Date: June 2, 2021  
To: Plan Holders  
Subject: Addendum No. 1 to the Bidding Documents for: ITB No. 2021-004

Hail Damaged HVAC Replacement Project  
Brookens Administrative Center  
1776 East Washington Street  
Urbana, Illinois

SEAL	DRAWN: JMD	APPROVED: RCVN	SHEET: <b>M-105</b>
	DATE: MAY 05, 2021	ISSUED FOR BID	
	PROJECT: GHR # 7321

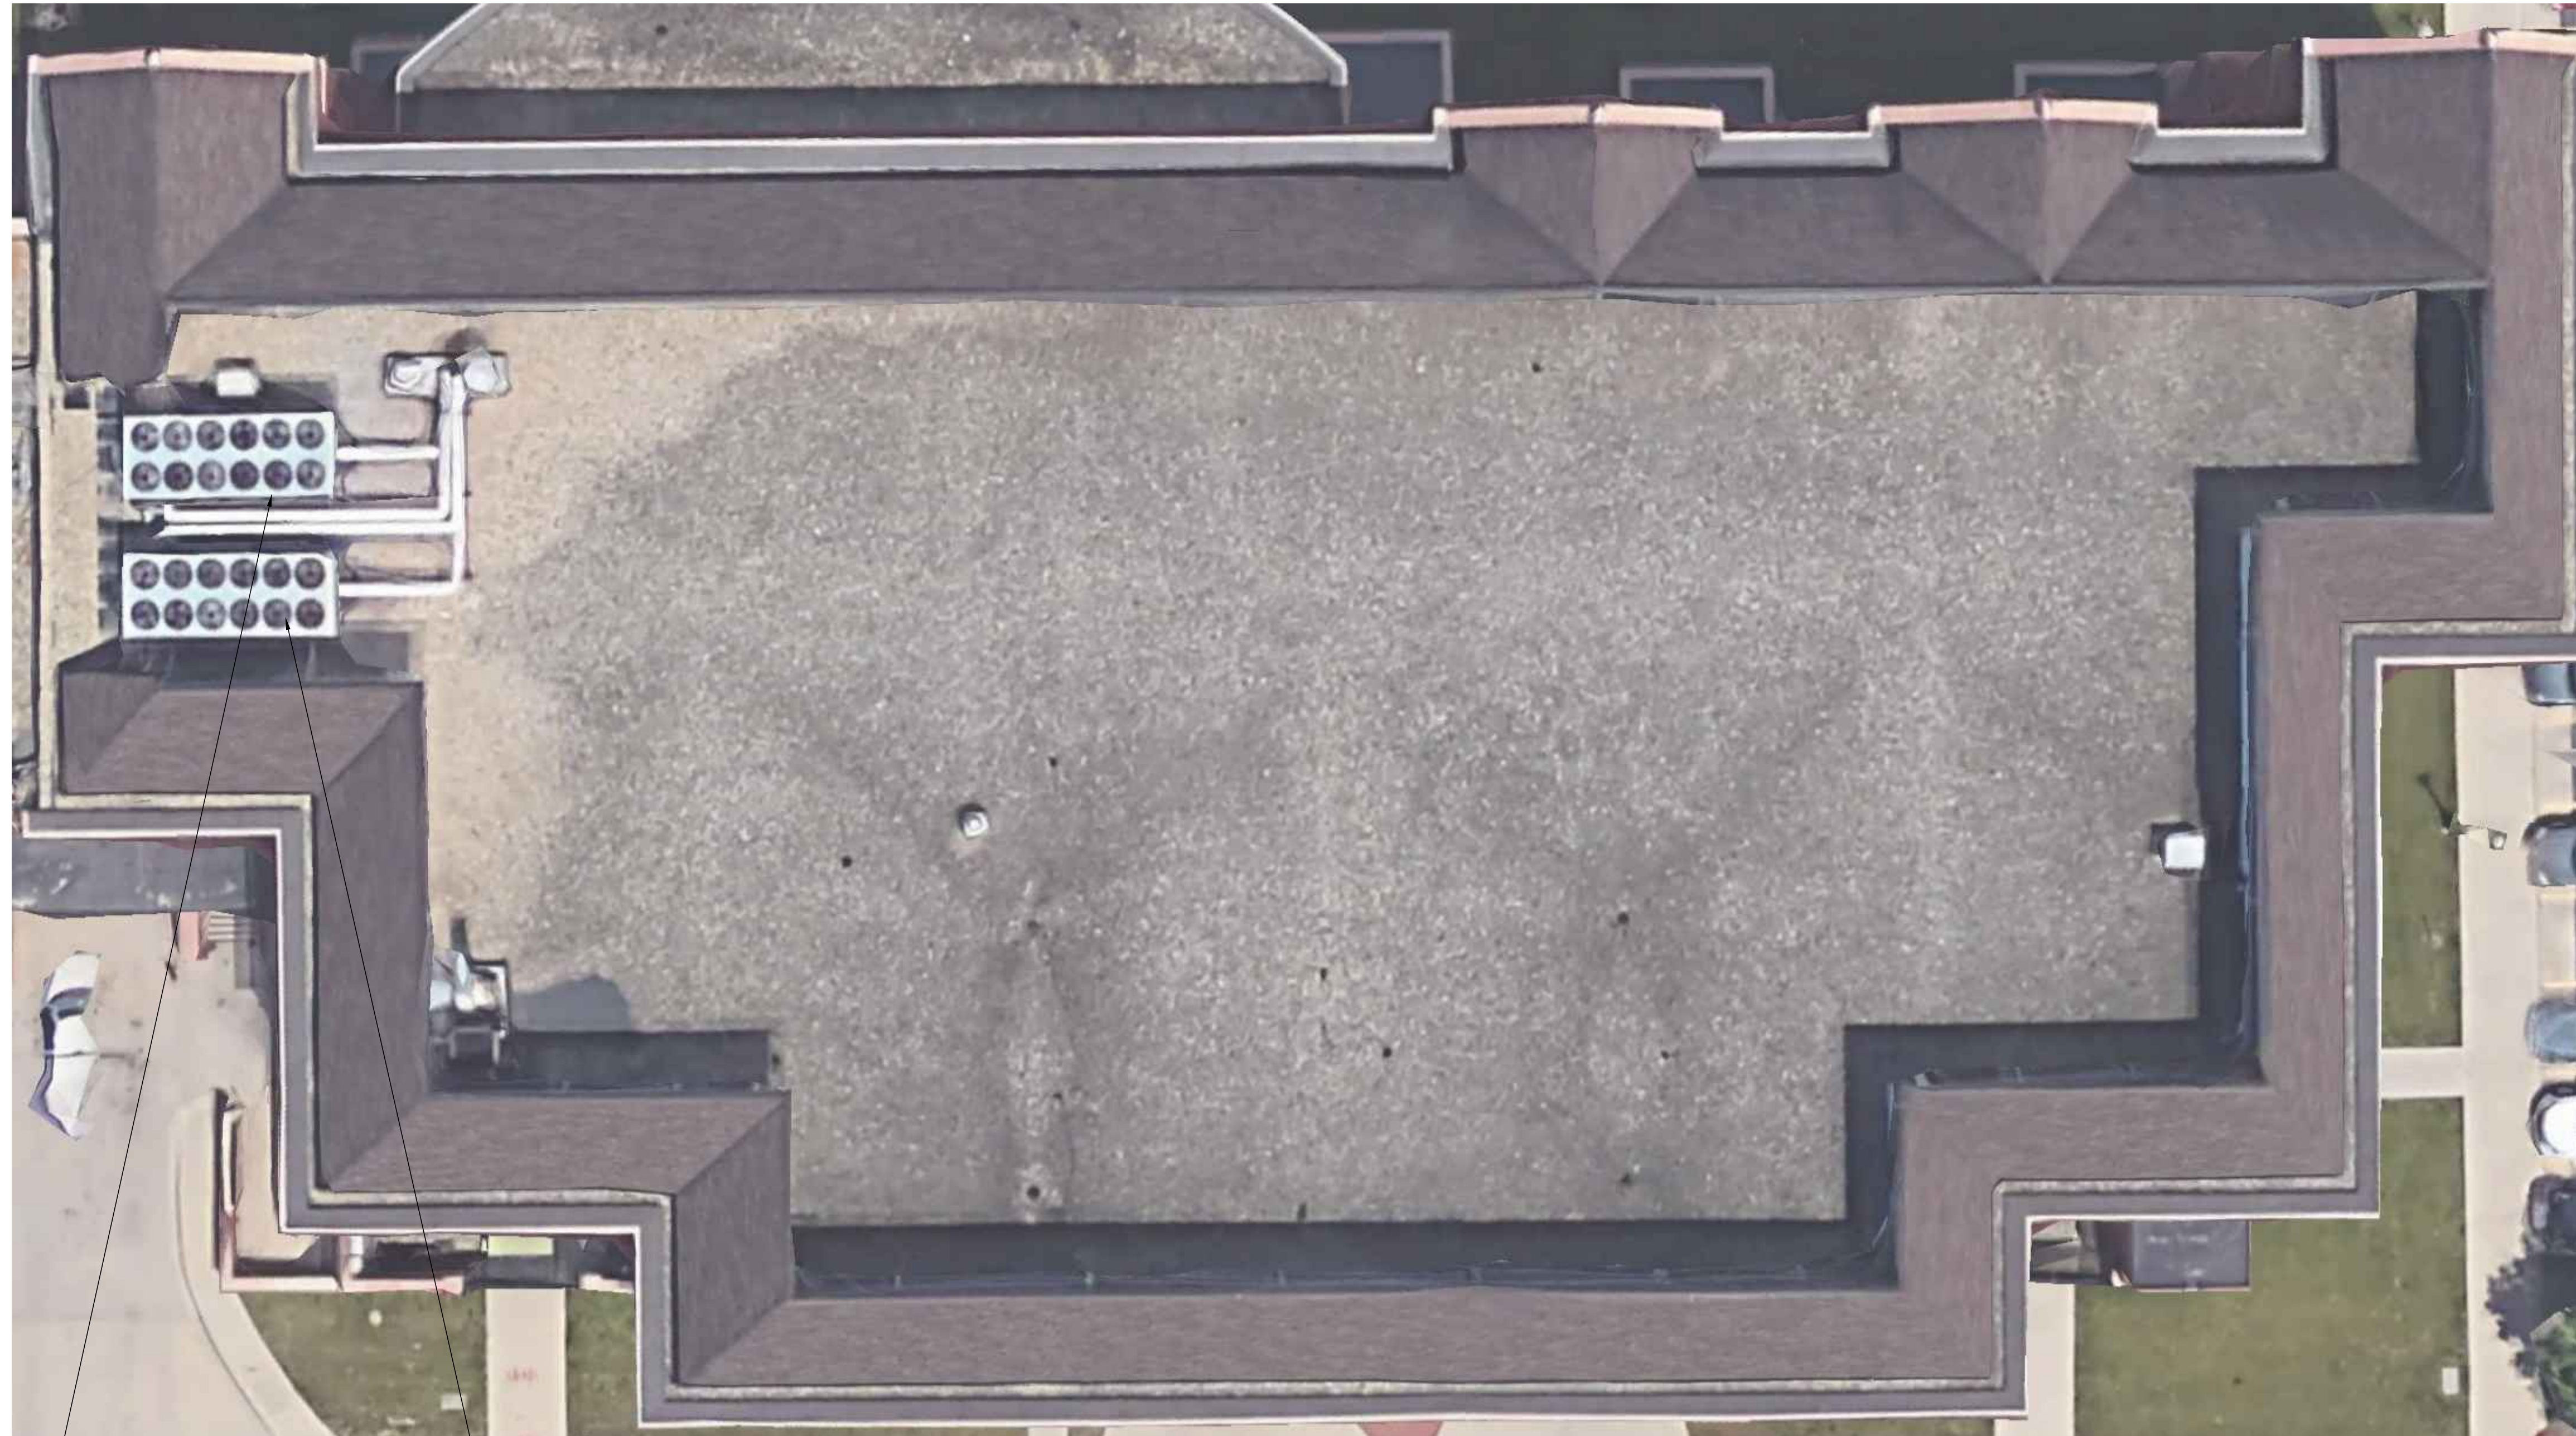
1. M-100 - BROOKENS POD 100 HVAC ROOF REPLACEMENT
  - a. ADD Keynote No. 4 to RTU-1, 2, 3, 4, 5, 6 7.
2. M-101 - BROOKENS POD 200 HVAC ROOF PLAN
  - a. REMOVE Keynotes No. 3 and No. 4 from Pod 200 YMH Unit.
  - b. REVISE Keynotes No. 3 and No. 4 to read "Keynote note used."
3. M-105 - CHAMPAIGN COUNTY COURTHOUSE HVAC ROOF PLAN
  - a. REVISE Keynotes No. 1 and No. 2. See attached sheet.

- KEYED NOTES - (FOR THIS PLAN ONLY)**
- 1. REMOVE CONDENSER COIL FROM EXISTING AIR COOLED CONDENSER. REMOVE CONDENSING UNIT FAN MOTORS AND CONDENSER FAN BLADES. INSTALL NEW COIL, NEW CONDENSER FAN MOTORS, AND CONDENSER FAN BLADES IN UNIT. COMB OUT COILS TO REPAIR BENT FINS TO THE SATISFACTION TO THE ENGINEER. INSTALL HAIL GUARDS.
  - 2. INSTALL HAIL GUARDS FROM CHILLER MANUFACTURER. COMB OUT COILS TO REPAIR BENT FINS TO THE SATISFACTION TO THE ENGINEER.
